Plant Name:  
Three Mile Island #1

Three Mile Island Nuclear Station Unit No. 1  
Docket Number 50-289

RESPONSES TO QUESTIONS RAISED IN ENCLOSURE 2

CONCERNING APPENDIX I

FIGURE 8-11

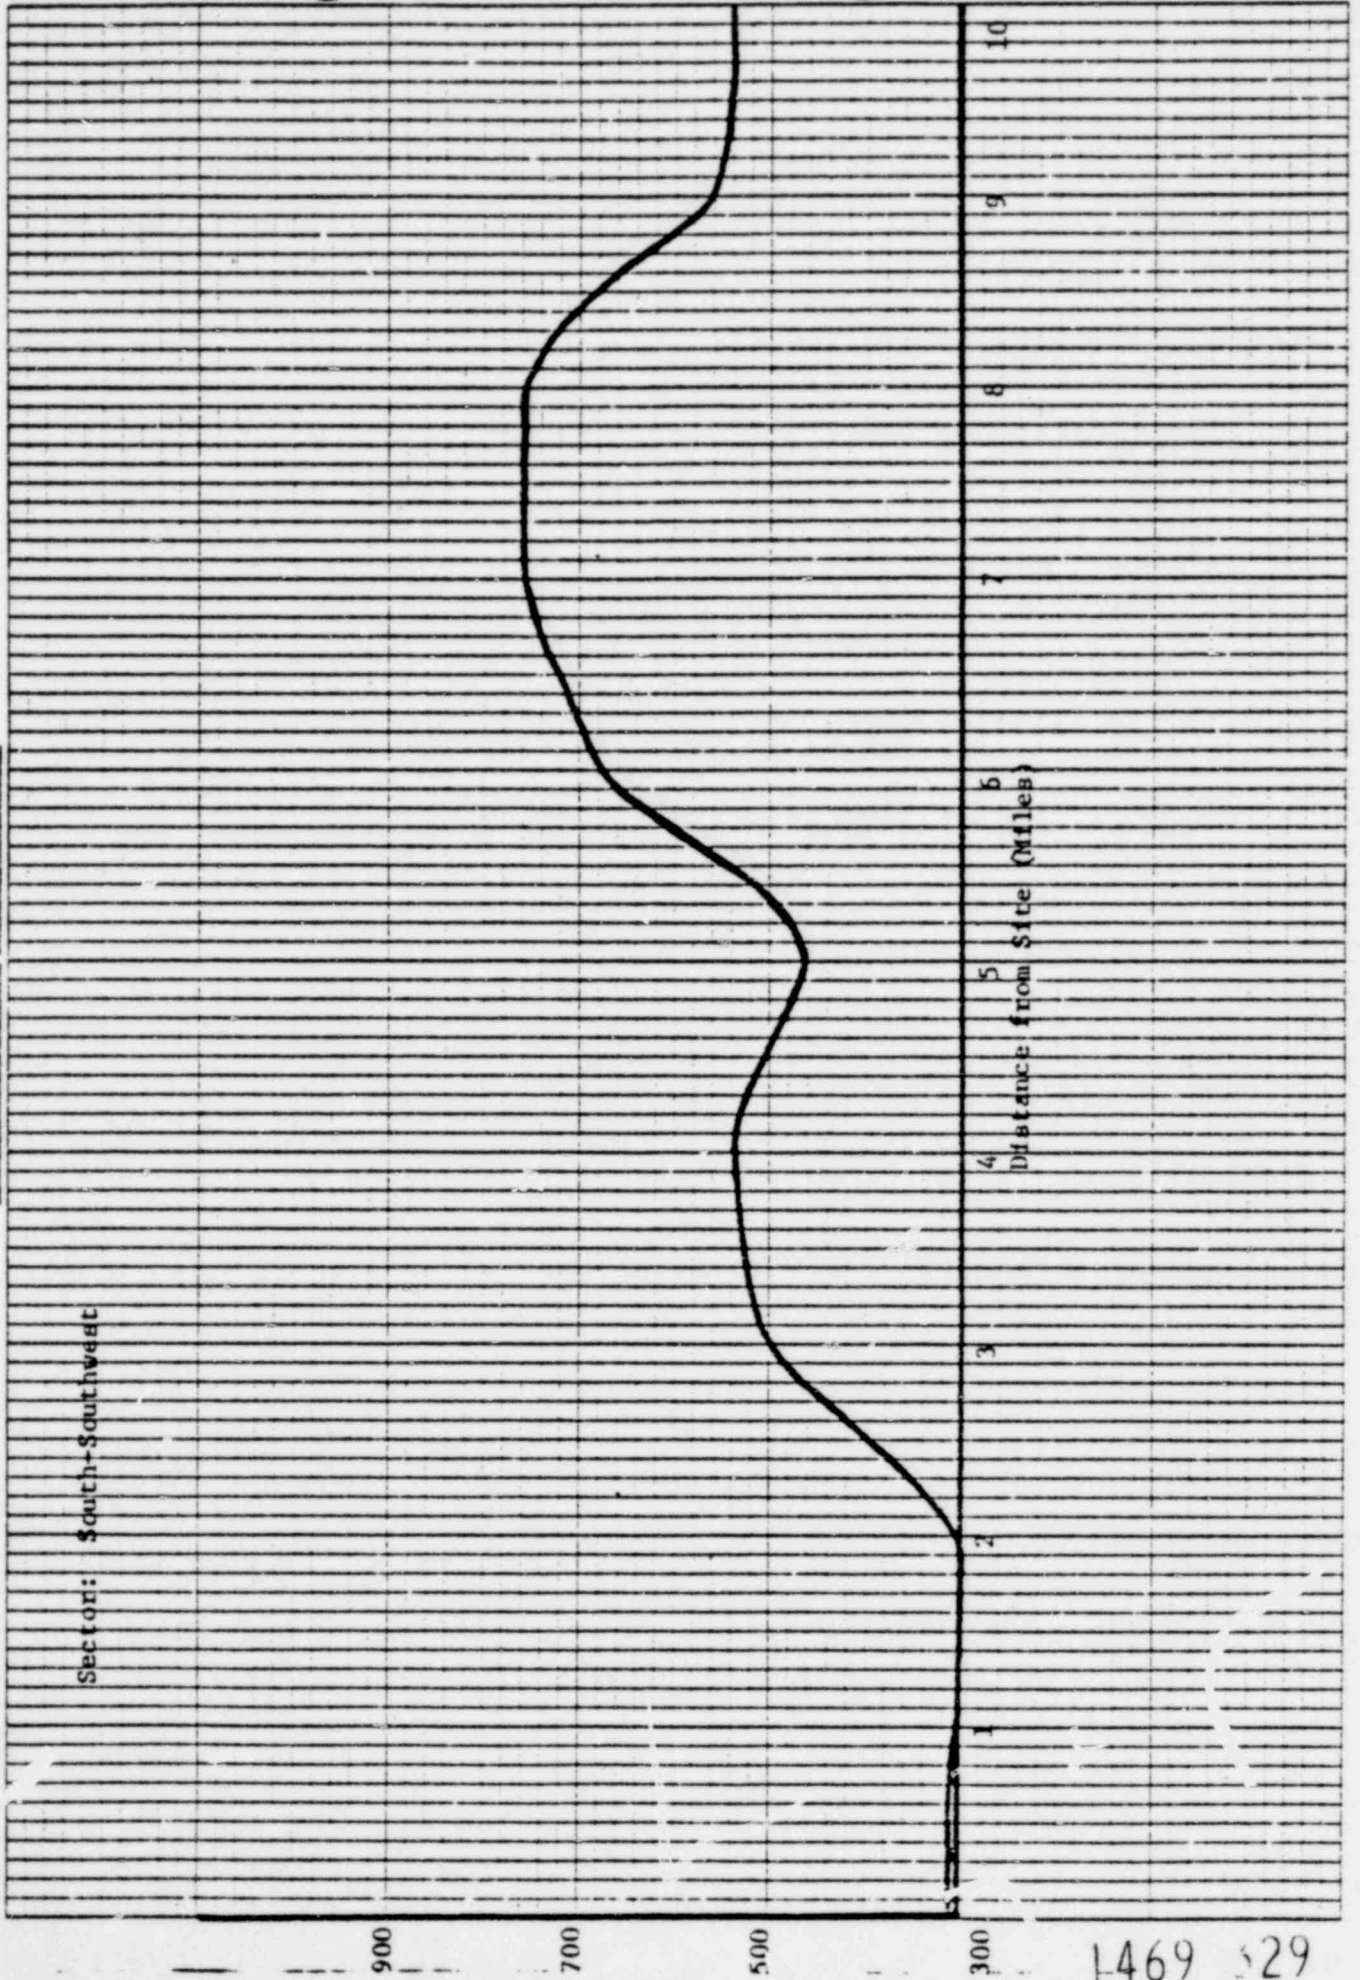
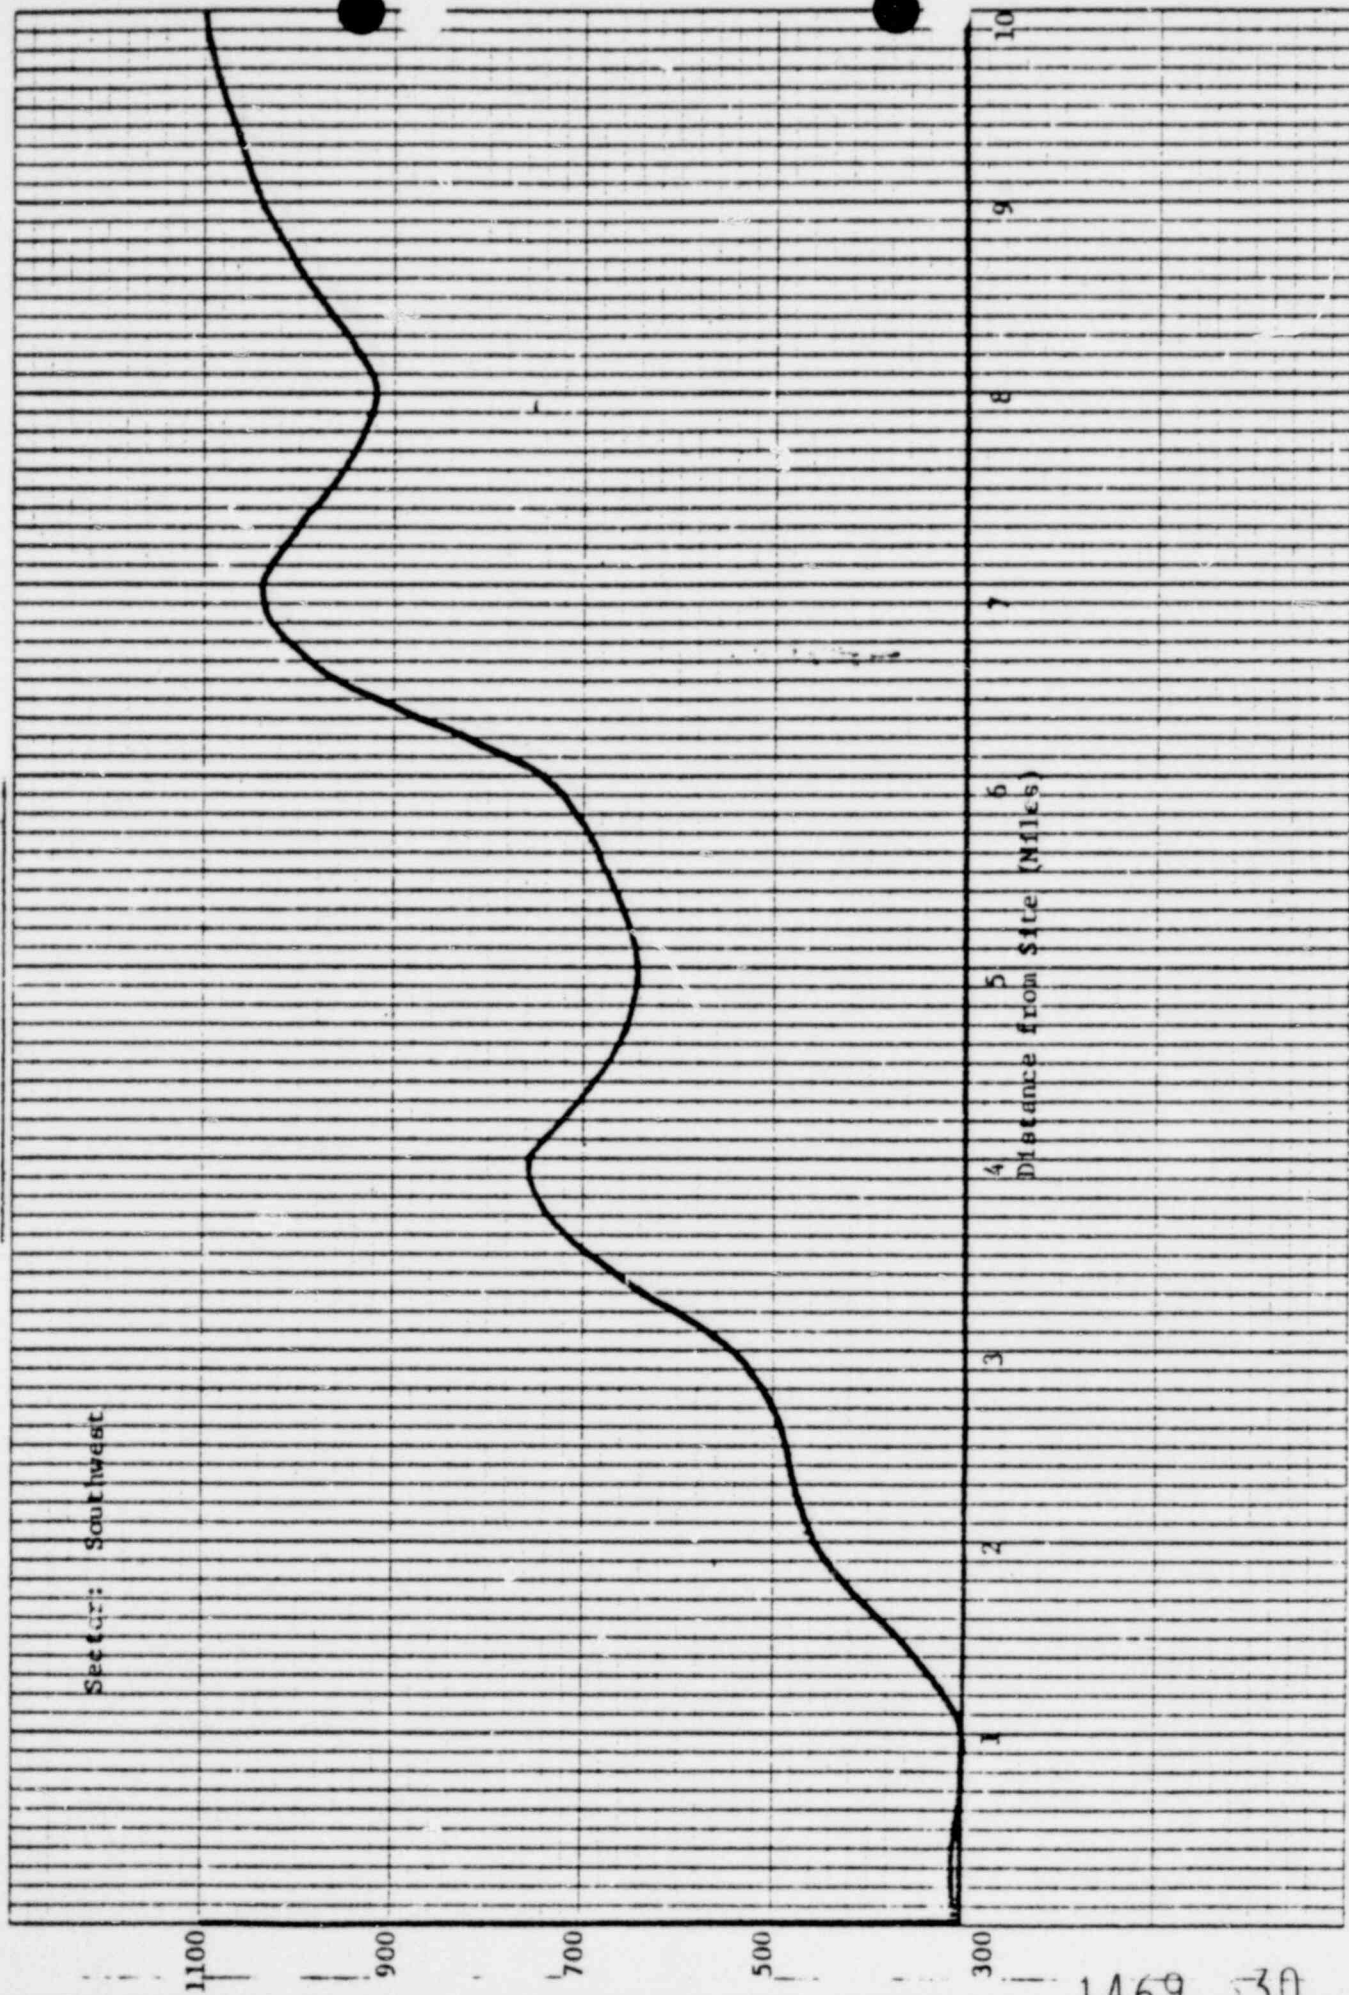
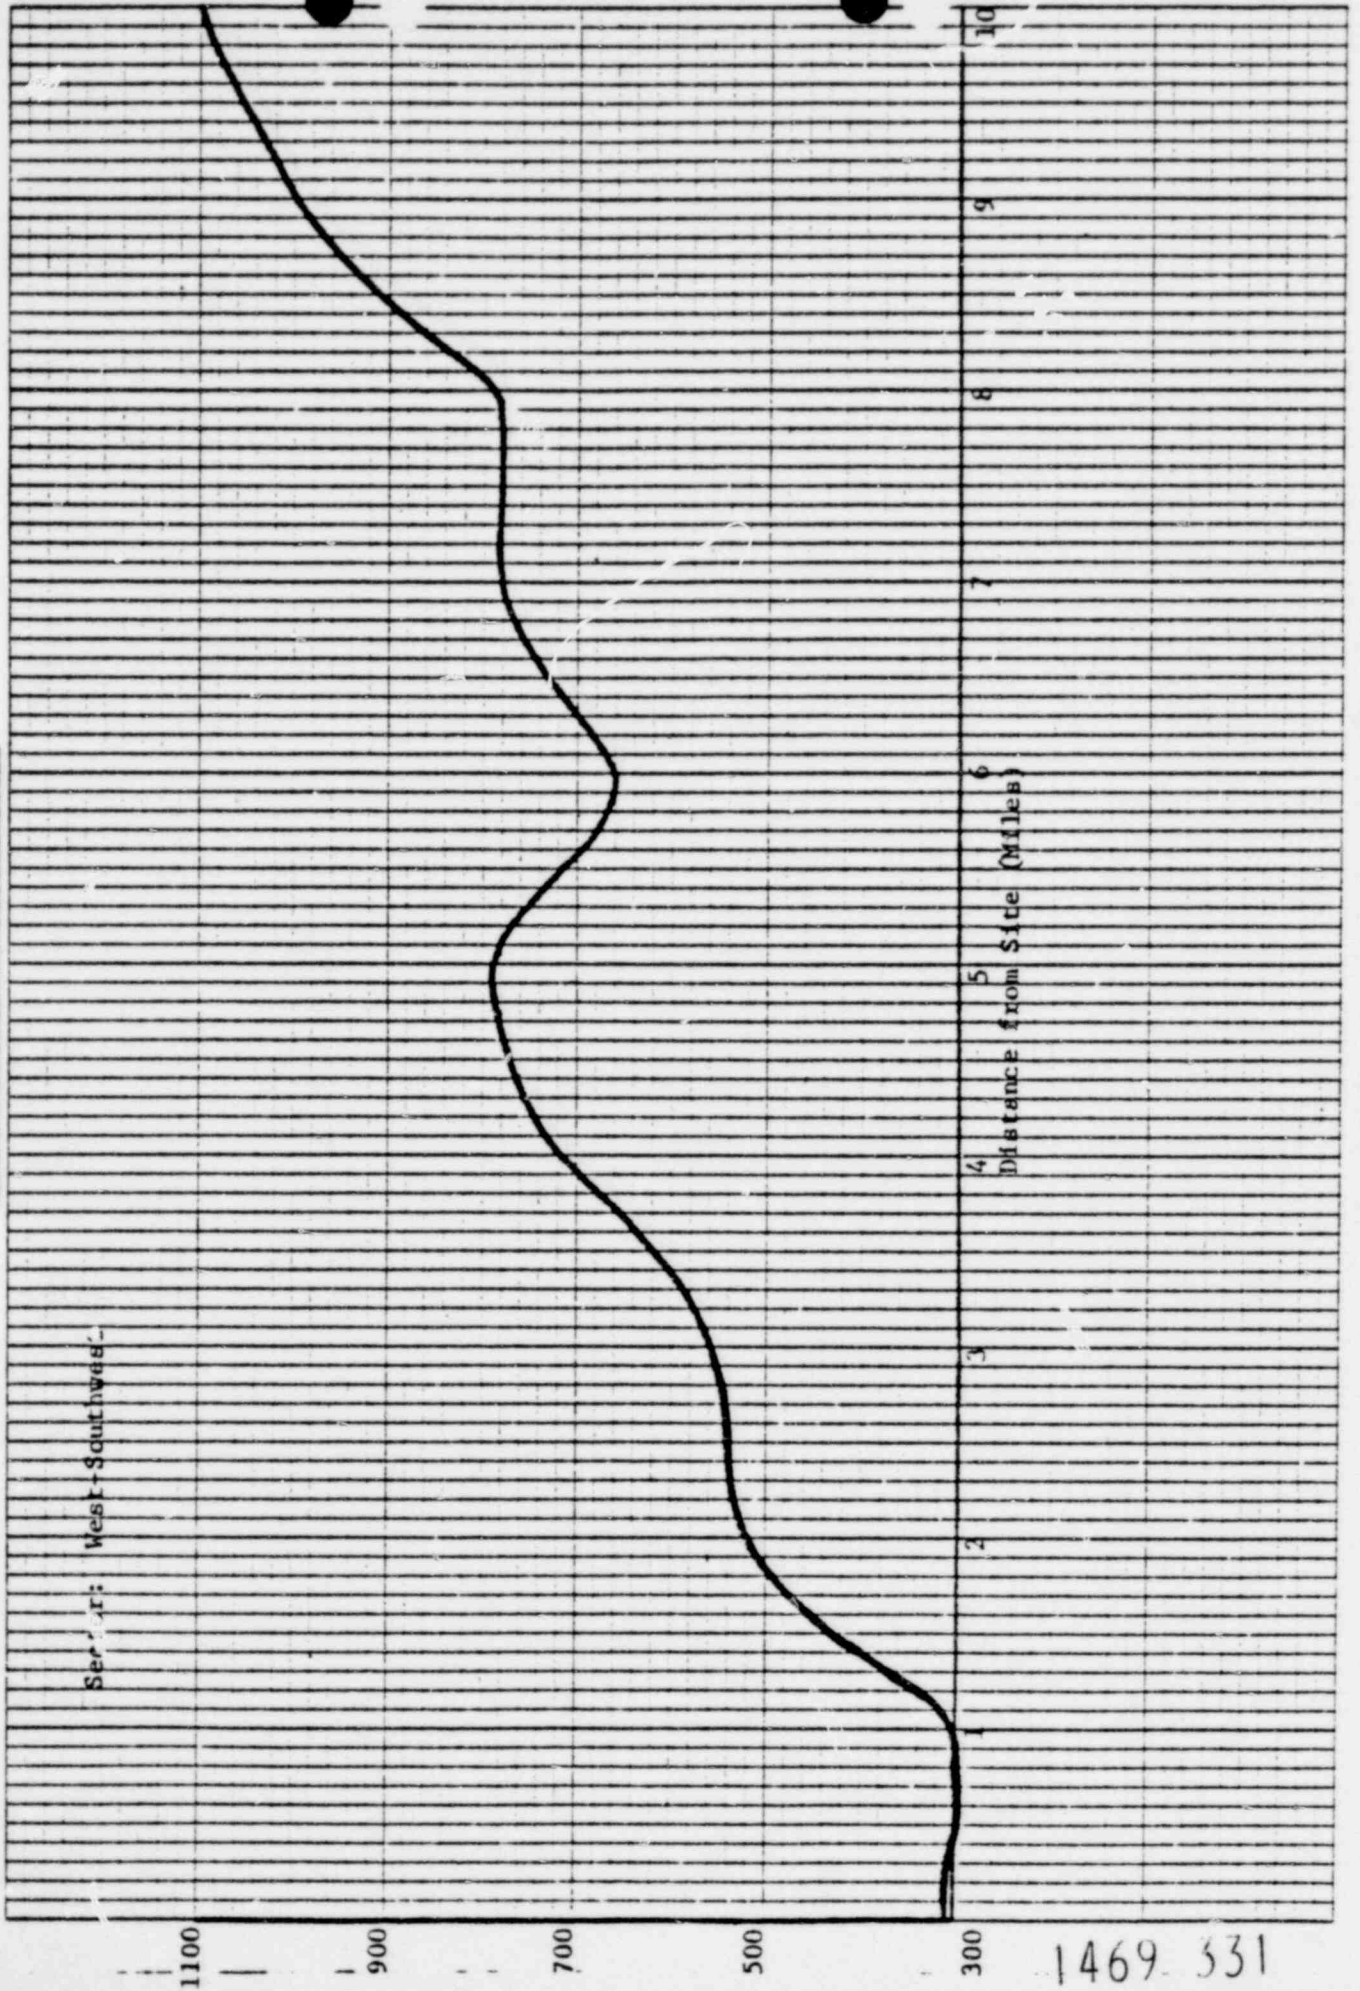
Provide a map showing the detailed topographical features (as modified by the plant) on a large scale, within a 10-mile radius of the plant and a plot of the maximum topographic elevation versus distance from the center of the plant in each of the sixteen 22-1/2 degree cardinal compass point sectors (centered on true north), radiating from the center of the plant, to a distance of 10 miles.

See attached Table 8-1 and Figures 8-1 through 8-16.
